VERMONT YANKEE NUCLEAR POWER CORPORATION

November 12, 1982

Subject: Alternate Shutdown System

ADDITIONAL CLARIFICATION

FIGURE 1

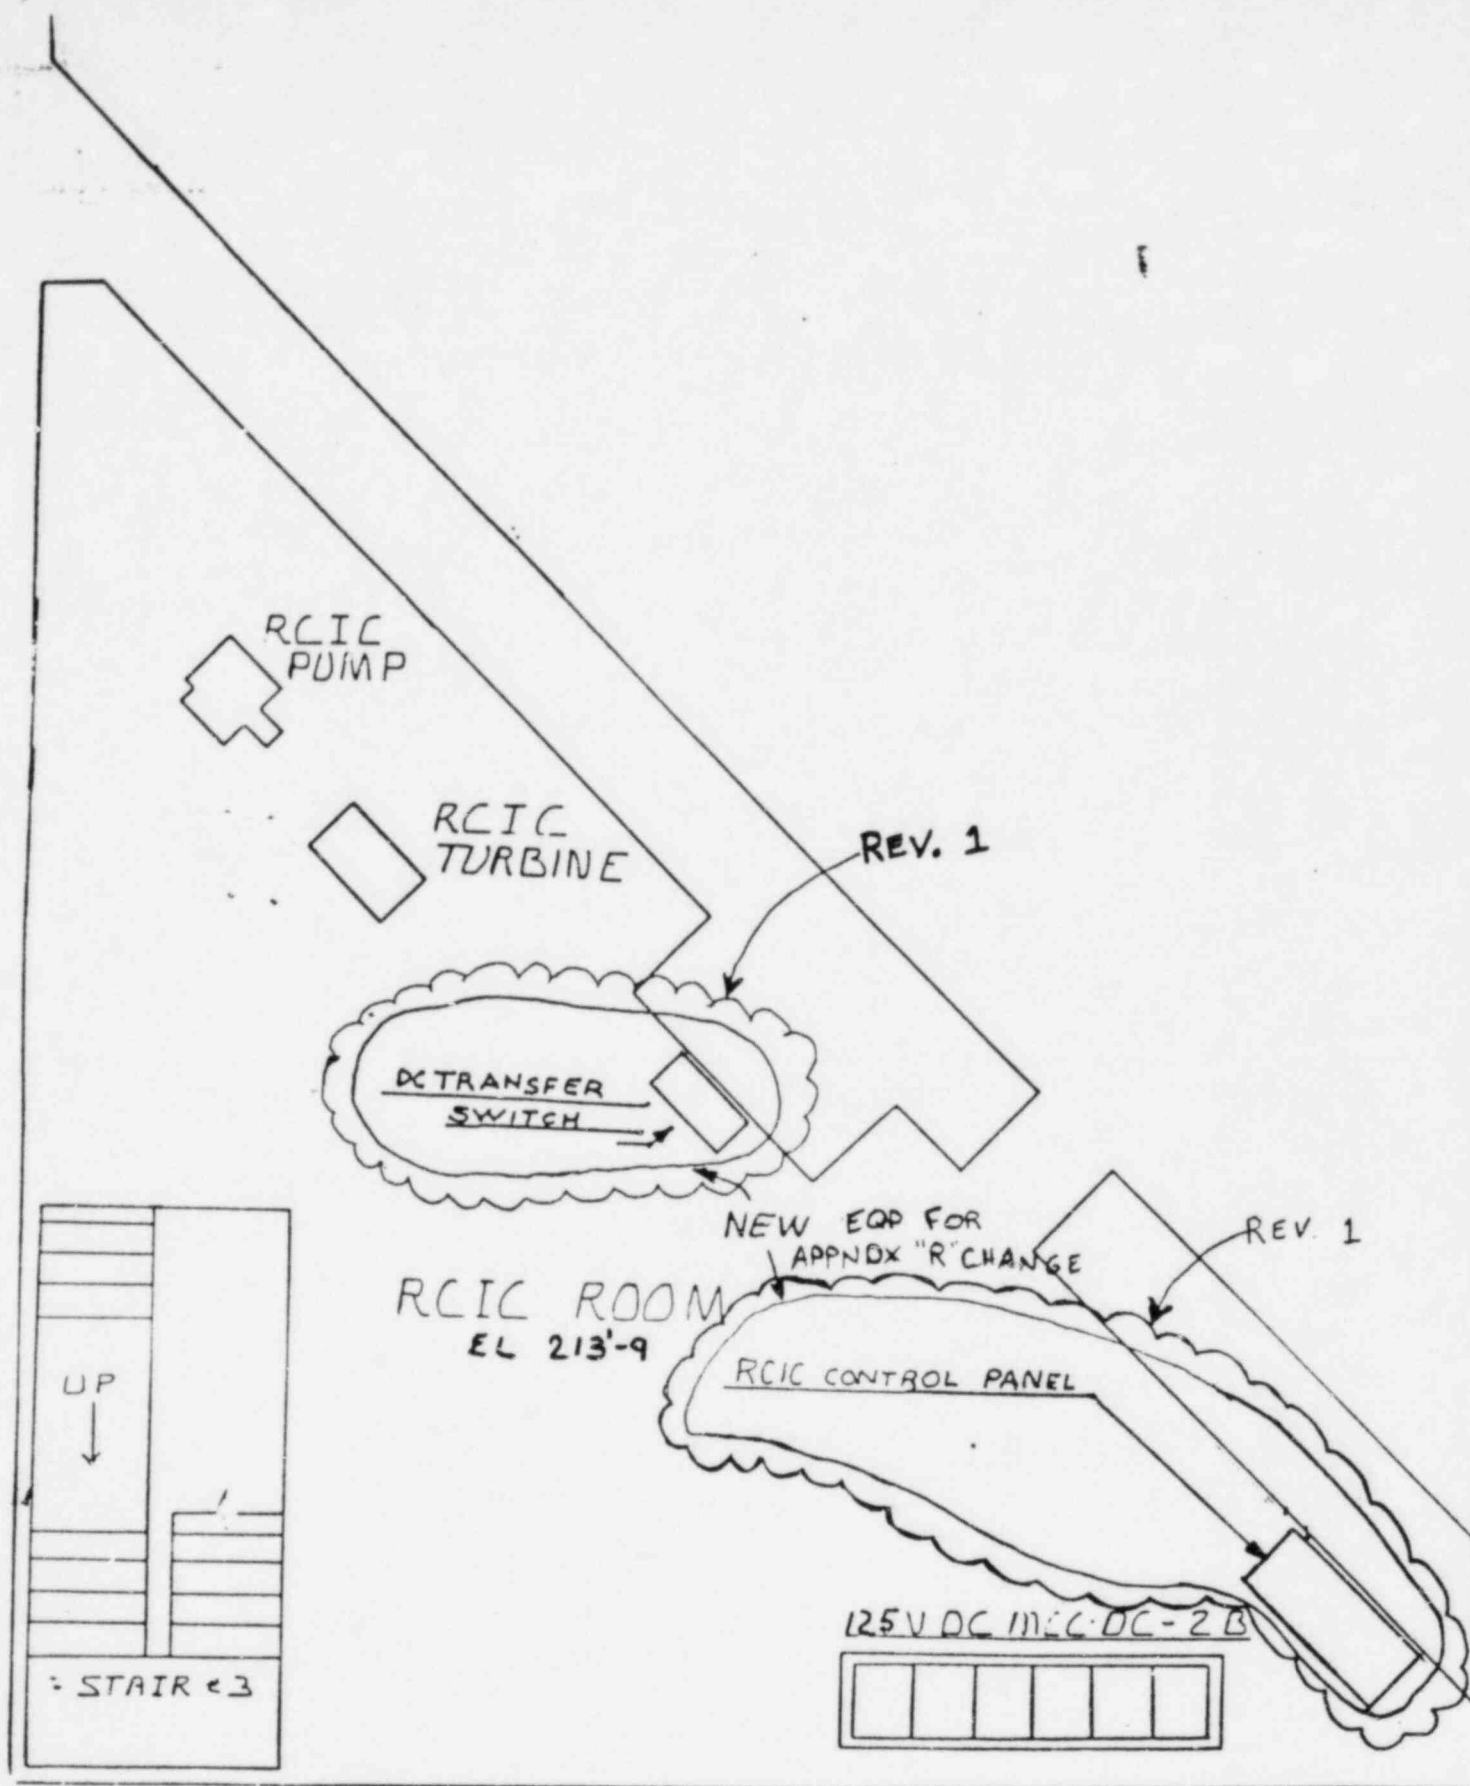
Figures 1, 3, 5, 6, and 8 have been revised. They now show that the station battery is the normal power supply for RCIC MOV-13-16, 4 kV Switchgear Bus 4 control power, and 480 V Switchgear Bus 9 control power. In the event of a fire, these loads will be manually transferred to the new dc power supply. These revised figures are attached and should be inserted in place of those originally submitted.

- ① CONTROL CIRCUITS ENTERING FIRE ZONES CAN BE ISOLATED BY SWITCHING AT THE RCIC PANEL
- ② CONTROL CIRCUITS ENTERING FIRE ZONES CAN BE ISOLATED BY SWITCHING AT THE RCIC PANEL. ALTERNATE CONTROL AND INDICATION IS PROVIDED AT THE RCIC PANEL.
- ③ CONTROL CIRCUITS ENTERING FIRE ZONES CAN BE ISOLATED BY SWITCHING LOCALLY AT A PANEL OUTSIDE THE FIRE ZONES. ALTERNATE CONTROL AND INDICATION IS PROVIDED AT THE SAME PANEL
- ④ CONTROL CIRCUITS AFFECTING OPERATION OF THE UPS WILL BE ISOLATED BY SWITCHING.

FIGURE 2

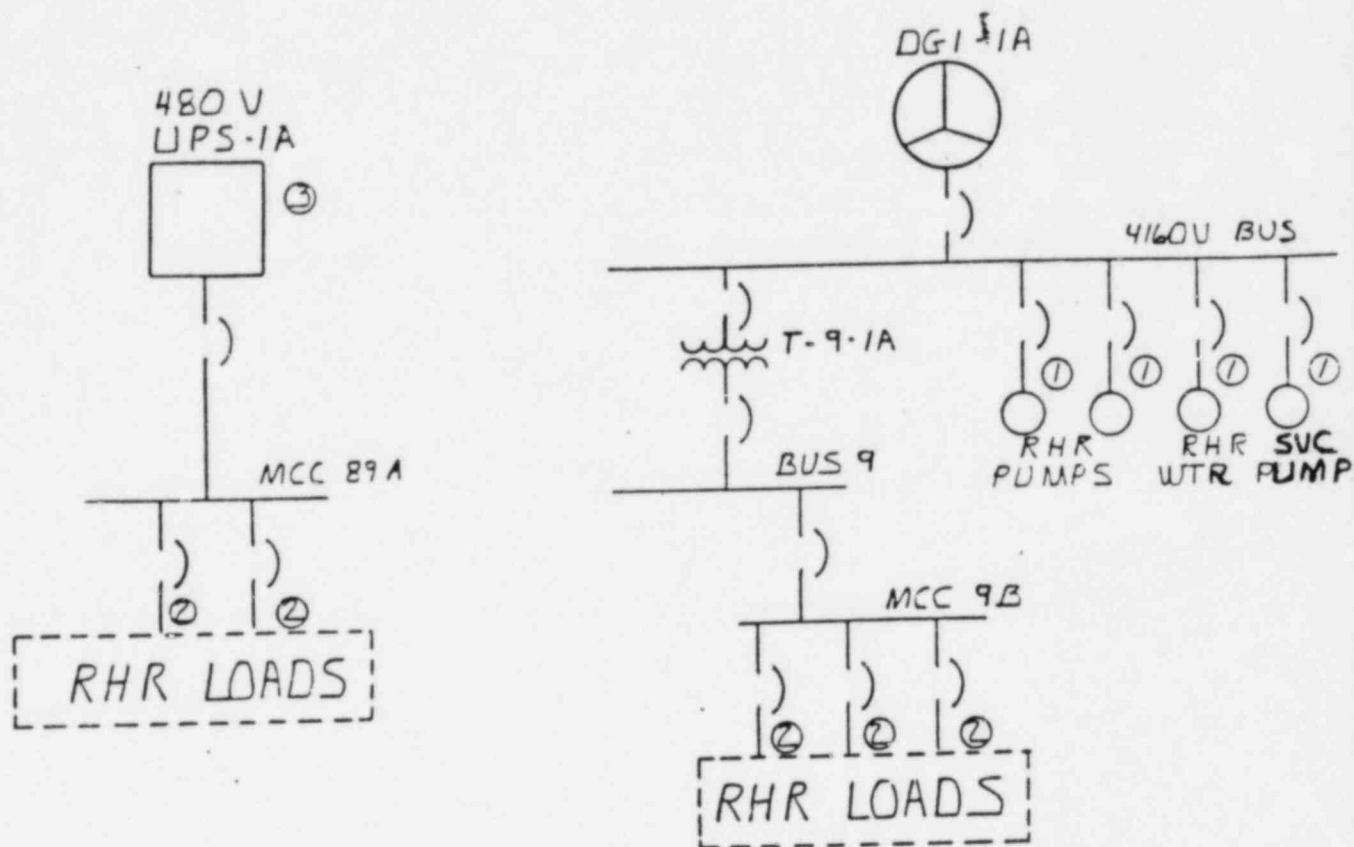
Figures 2 and 7 have been revised to show changes to equipment locations. These should also be inserted in place of those originally submitted.

FIGURE 3

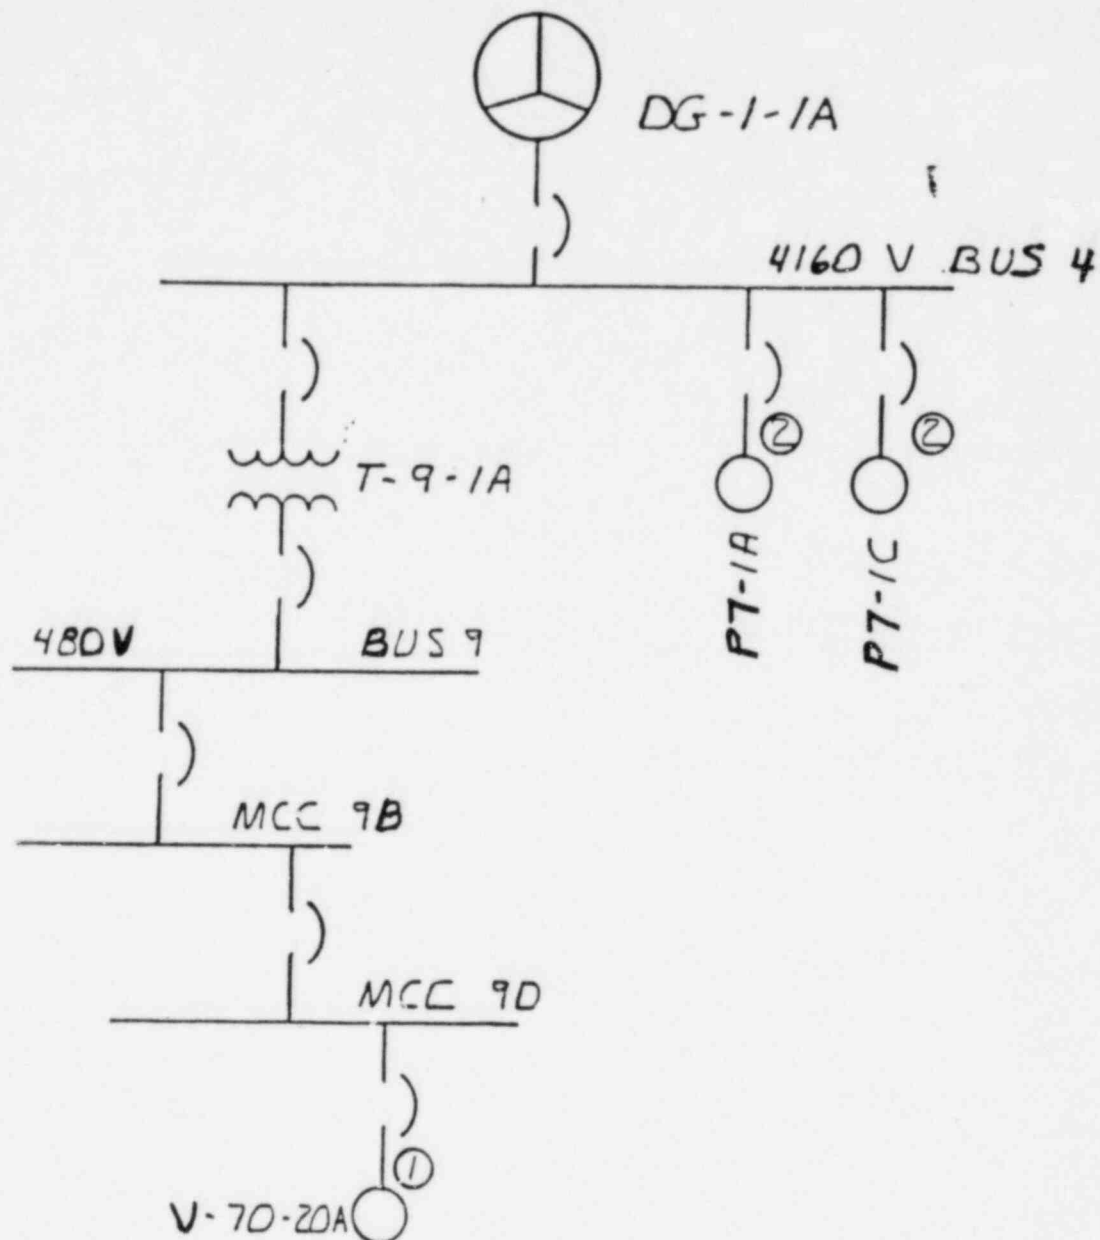
- ① 125 VDC CONTROL POWER INDEPENDENT OF THE FIRE ZONES WILL BE PROVIDED BY MANUALLY OPERATED TRANSFER SWITCHES CONNECTED TO THE NEW BATTERY. CONTROL CIRCUITS ENTERING FIRE ZONES WILL BE ISOLATED BY SWITCHES LOCATED IN THE INDIVIDUAL COMPARTMENTS OF THE SWITCHGEAR.
- ② CONTROL CIRCUITS ENTERING FIRE ZONES CAN BE ISOLATED LOCALLY BY SWITCHING AT THE RHR PANEL WHICH IS OUTSIDE FIRE ZONES. ALTERNATE CONTROL AND INDICATION IS PROVIDED AT THE RHR PANEL.
- ③ CONTROL CIRCUITS AFFECTING OPERATION OF THE UPS WILL BE ISOLATED BY SWITCHING.

FIGURE 5

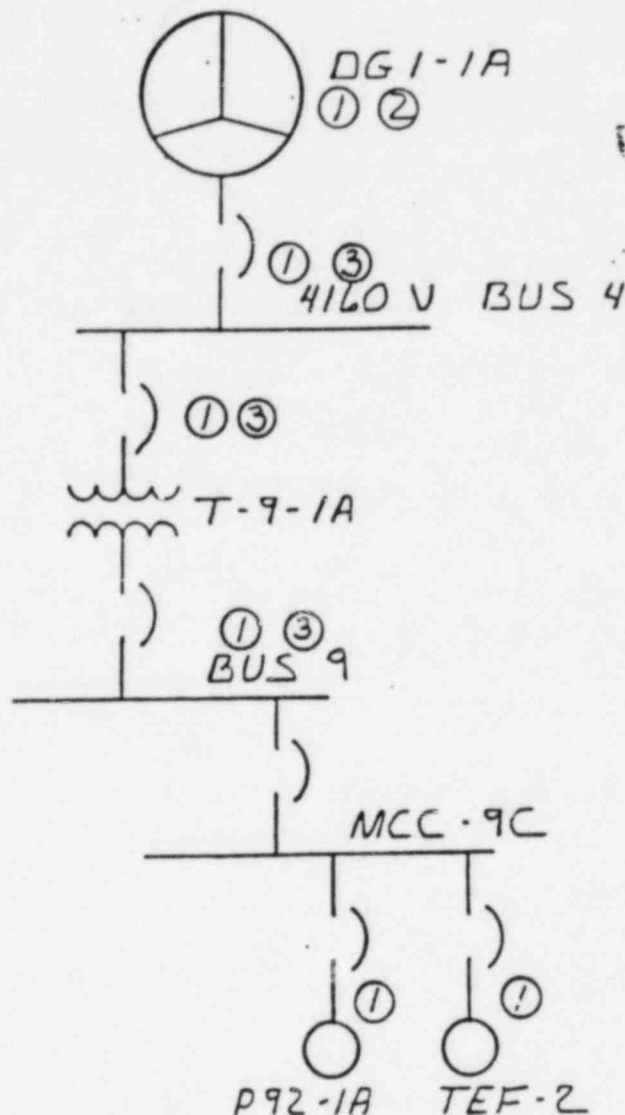
① CONTROL CIRCUITS ENTERING FIRE ZONES CAN BE ISOLATED LOCALLY BY SWITCHING AT THE RHR PANEL WHICH IS OUTSIDE THE FIRE ZONES. ALTERNATE CONTROL AND INDICATION IS PROVIDED AT THE RHR PANEL

② 125 V DC CONTROL POWER INDEPENDENT OF THE FIRE ZONES WILL BE PROVIDED BY MANUALLY OPERATED TRANSFER SWITCHES CONNECTED TO THE NEW DIESEL GENERATOR 1-1A BATTERY. CONTROL CIRCUITS ENTERING FIRE ZONES WILL BE ISOLATED BY SWITCHES LOCATED IN THE INDIVIDUAL COMPARTMENT OF THE SWITCHGEAR.

FIGURE 6

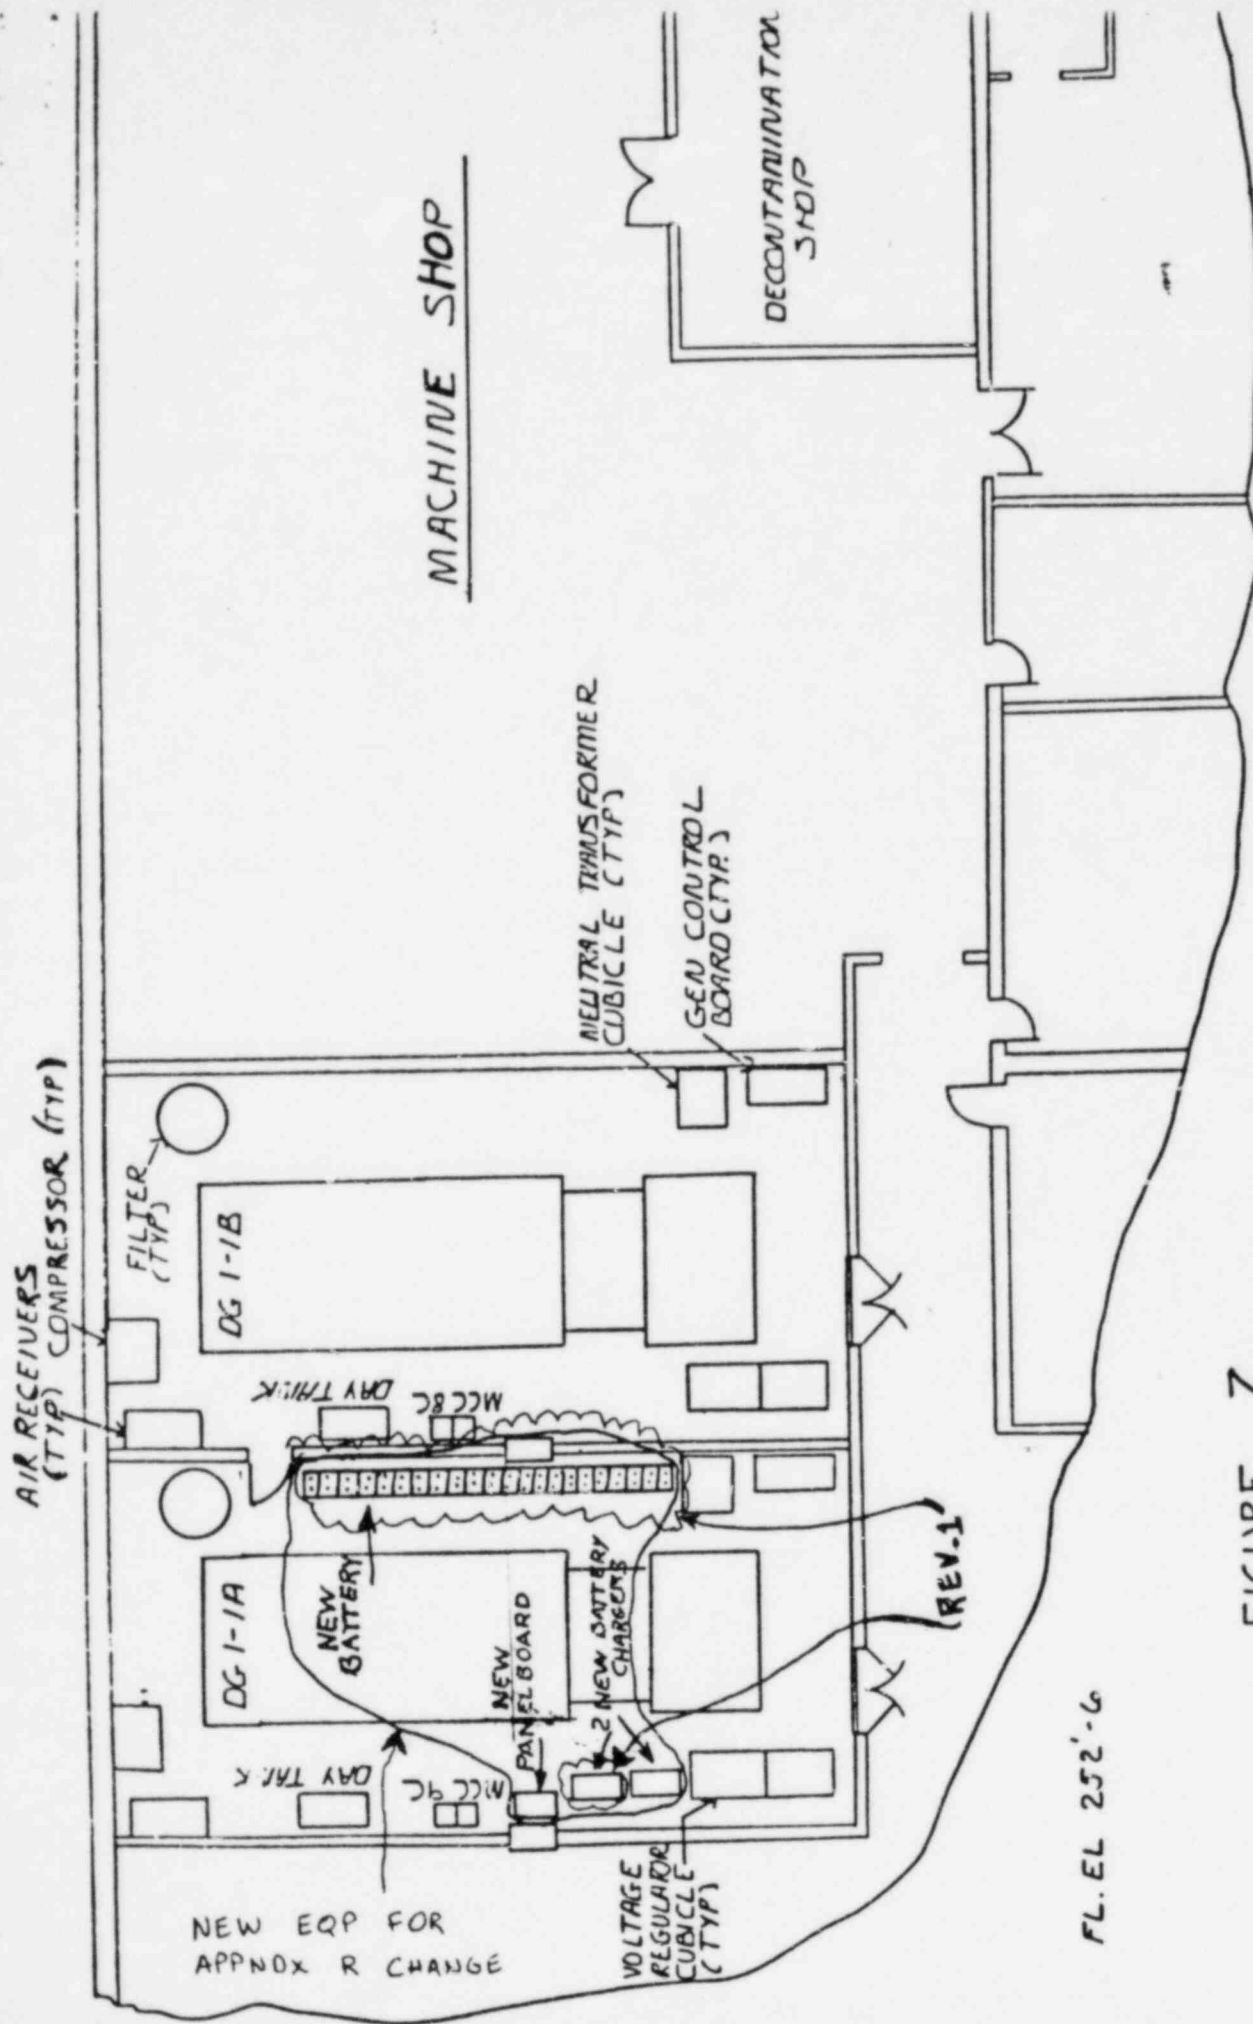
- ① CONTROL CIRCUITS ENTERING FIRE ZONES AND AFFECTING DIESEL OPERATION WILL BE ISOLATED BY SWITCHING OUTSIDE THE FIRE ZONES. LOCAL CONTROLS WILL BE PROVIDED FOR OPERATION OF DIESEL AND AUXILIARIES.
- ② 125 V DC CONTROL POWER INDEPENDENT OF THE FIRE ZONES WILL BE PROVIDED BY NEW CLASS 1E BATTERY.
- ③ 125 V DC CONTROL POWER INDEPENDENT OF THE FIRE ZONES WILL BE PROVIDED BY MANUALLY OPERATED TRANSFER SWITCHES CONNECTED TO A NEW BATTERY
